# Access Compliance Report

## Public Rights-of-Way

### (Curb Ramps)

Intersection ID: 12711	Main Street: W_STONEWALL_ST	Cross Street: W_STONEWALL_ST	Location: N
ADA ID: 23D1F65BCA9F	Ramp Type: Perp	Initial Pass/Fail: Fail	Overall Compliance: No
			Severity Score: 13.75

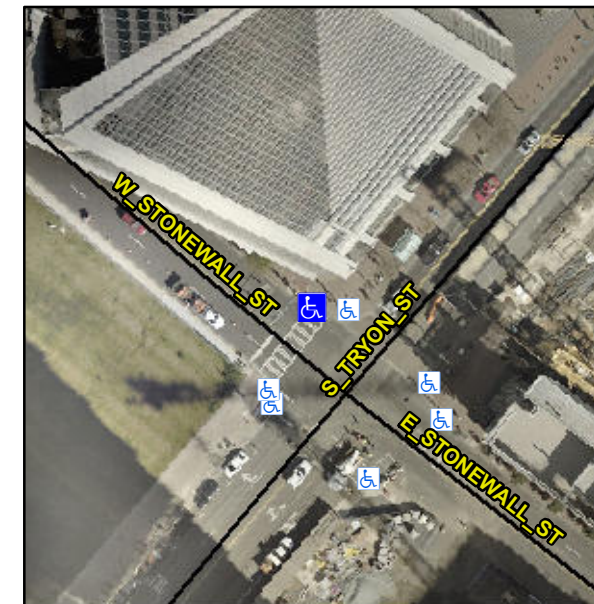
**R304.2.2, R304.5.3**

Compliance	Description	Data	Compliance	Description	Data
N/A	Ramp Length (in)	69.0	No	Ramp Slope (%)	9.2
Yes	Ramp Width (in)	56.0	No	Ramp XSlope (%)	4.8
N/A	Flare Type LT	N/A	N/A	Flare Type RT	N/A
N/A	Flare Slope LT (%)	N/A	N/A	Flare Slope RT (%)	N/A
N/A	Flare Traversable LT?	N/A	N/A	Flare Traversable RT?	N/A
N/A	Landing Length (in)	N/A	N/A	DWS Provided?	N/A
N/A	Landing Width (in)	N/A	N/A	DWS Contrast?	N/A
N/A	Landing Slope (%)	N/A	N/A	DWS Length (in)	N/A
N/A	Landing X Slope (%)	N/A	N/A	DWS Full Width?	N/A
N/A	Landing Curb? (Y/N)	N/A	N/A	DWS Offset (in)	N/A
N/A	Shared Landing?	N/A			
N/A	Gutter Ponding?	N/A	N/A	Gutter Slope (%)	N/A
N/A	Gutter Lip Ht (in)	N/A	N/A	Gutter X Slope (%)	N/A
N/A	Painted X Walk1?	Yes	N/A	Painted X Walk2?	N/A
	X Walk 1 Direction	To SW		X Walk 2 Direction	N/A
N/A	X Walk 1 Width (in)	115.0	N/A	X Walk 2 Width (in)	N/A
	X Walk 1 Slope (%)	0.5		X Walk 2 Slope (%)	N/A
	X Walk 1 X Slope (%)	1.4		X Walk 2 X Slope (%)	N/A

**Remove & Replace Entire Ramp.**
